RE: SWD-684
Sand Tank 32 State Com #2
1650' FSL - 1650' FEL
Section 32-17S-30E
Eddy County, New Mexico

**SWD Conversion
Wolfcamp Dolomite
6 June 2001**

RE: Sand Tank 32 State Com #2
Administrative Order SWD-684
Request for Approval to Modify Injection Interval
Section 32-175-30E – Eddy County, New Mexico

III
EXHIBIT A
WELL SCHEMATIC

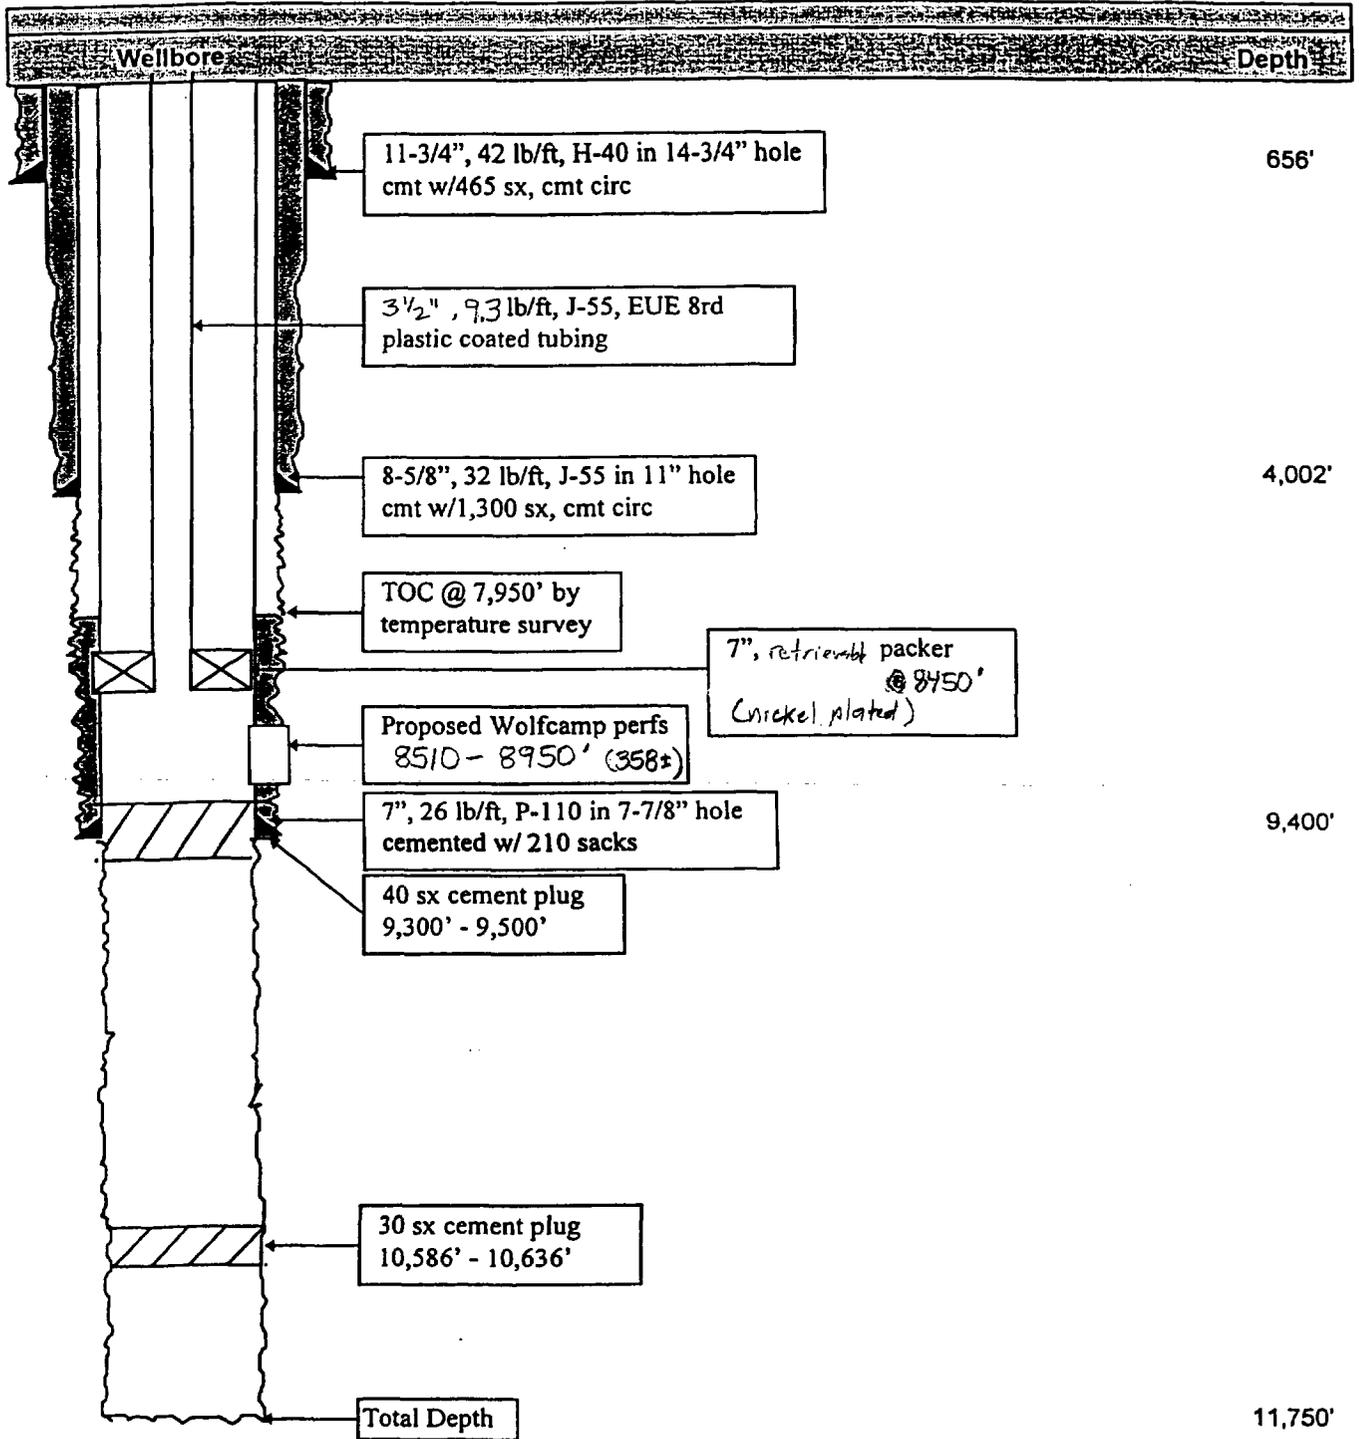
Marbob Energy Corporation has taken over operatorship of the captioned well from Enron Oil and Gas (EOG). Marbob is in the process of converting this well to salt water disposal service and requests approval to change the Wolfcamp disposal interval from 8600' – 8900' to 8510' – 9100'. The revised injection interval is still in the Wolfcamp and is necessary to ensure maximum injectivity at the lowest injection pressure. We propose to limit the maximum surface injection pressure to 1702 psi (0.2 psi/ft x 8510'). Everything else in the original application remains the same, and there is no change in the wells within the area of review.

Marbob Energy Corporation respectfully requests that Administrative Order SWD-684 be changed to reflect the new injection interval, new injection pressure limit, and new operator (Marbob).
